SURRY POWER STATION

PROPOSED TECHNICAL SPECIFICATION CHANGES

**DISCUSSION OF CHANGES AND
SIGNIFICANT HAZARDS CONSIDERATION**

**SURRY POWER STATION
SURRY CORE UPRATE LICENSING REPORT**

**TS FIGURE 2.1-1
REACTOR CORE THERMAL AND
HYDRAULIC SAFETY LIMITS
THREE LOOP OPERATION, 100% FLOW**

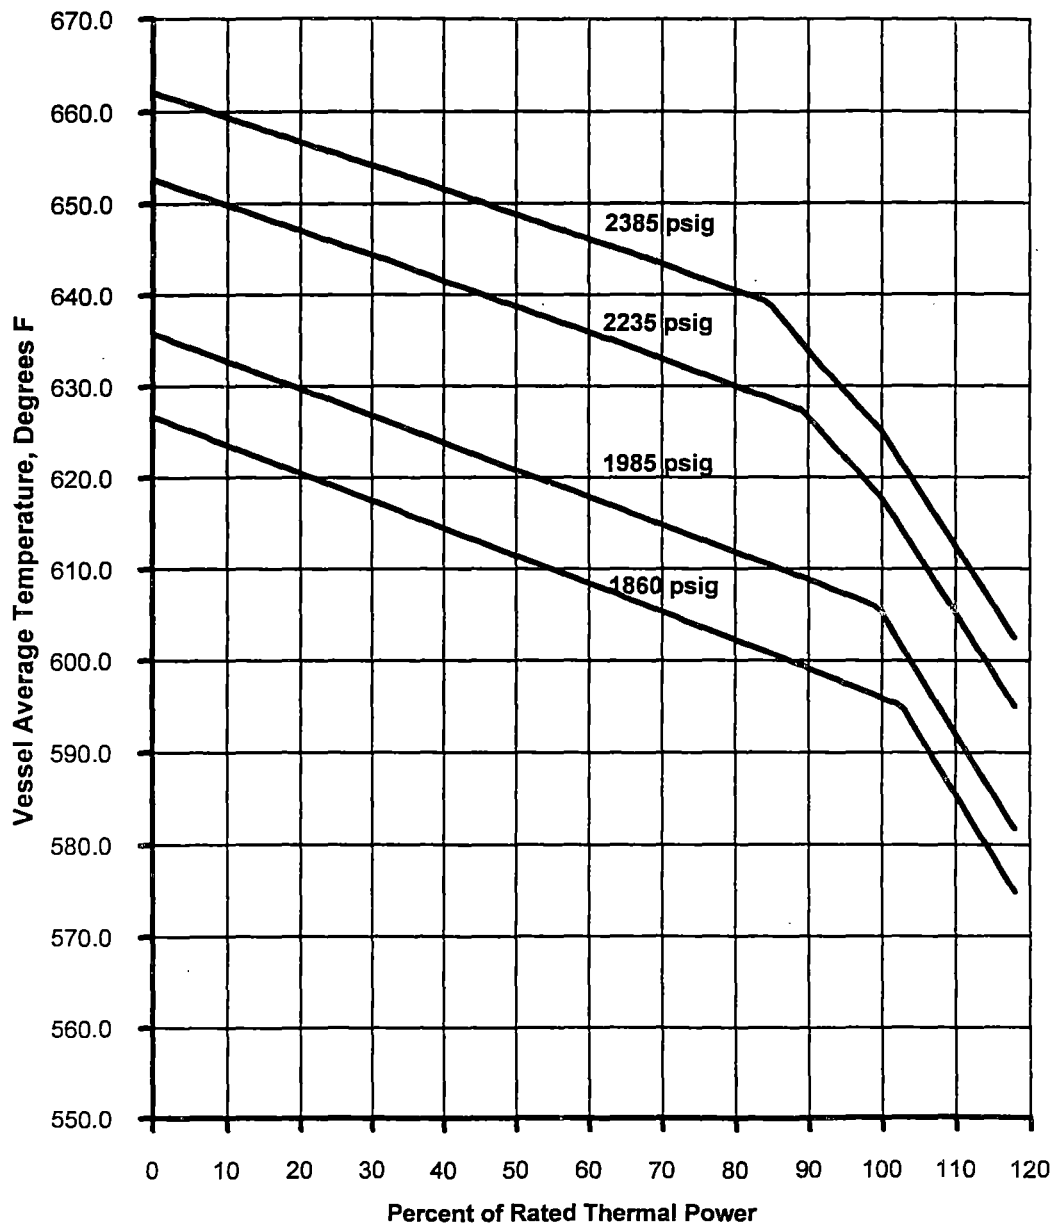
The curves of TS Figure 2.1-1 which show the allowable power level decreasing with increasing temperature at selected pressures for constant flow (three loop operation) represent limits equal to, or more conservative than, the loci of points of thermal power, coolant system average temperature, and coolant system pressure for which the calculated DNBR is not less than the design DNBR limit or the average enthalpy at the exit of the vessel is equal to the saturation value. The area where clad integrity is assured is below these lines. The temperature limits are considerably more conservative than would be required if they were based upon the design DNBR limit alone but are such that the plant conditions required to violate the limits are precluded by the self-actuated safety valves on the steam generators. The effects of rod bowing are also considered in the DNBR analyses.

TS Figure 2.1-1 is based on a 1.55 cosine axial flux shape and a statistical treatment of key DNBR analysis parameter uncertainties including an enthalpy rise hot channel factor which follows the following functional form: $F\Delta H(N) = 1.56 [1 + 0.3(1-P)]$ where P is the fraction of RATED POWER. The limits include margin to accommodate rod bowing.⁽¹⁾ TS Figures 2.1-2 and 2.1-3 are based on an $F\Delta H(N)$ of 1.55, a deterministic treatment of key DNB analysis parameter uncertainties, and include a 0.2 rather than 0.3 part power multiplier for the enthalpy rise hot channel factor. The $F\Delta H(N)$ limit presented in the unit- and reload-specific CORE OPERATING LIMITS REPORT is confirmed for each reload to be accommodated by the Reactor Core Safety Limits.

TS FIGURE 3.8-1

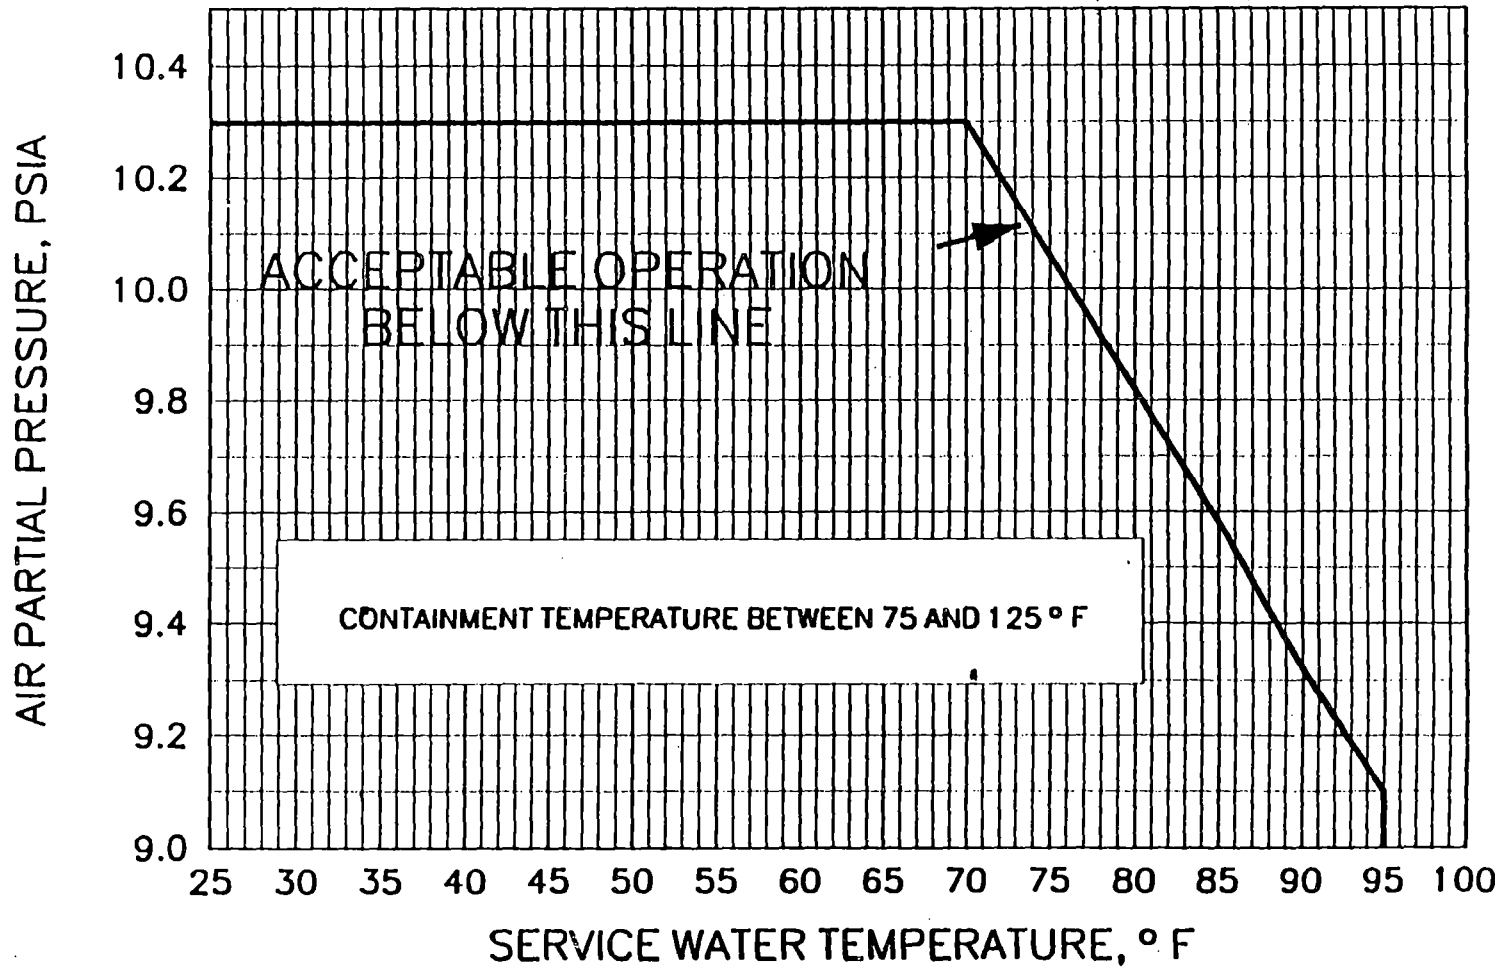
The allowable value for the containment air partial pressure is presented in TS Figure 3.8-1 for service water temperatures from 25 to 95°F. The RWST water shall have a maximum temperature of 45°F.

The horizontal limit line in TS Figure 3.8-1 is based on LOCA peak calculated pressure criteria, and the sloped line is based on LOCA subatmospheric peak pressure criteria.
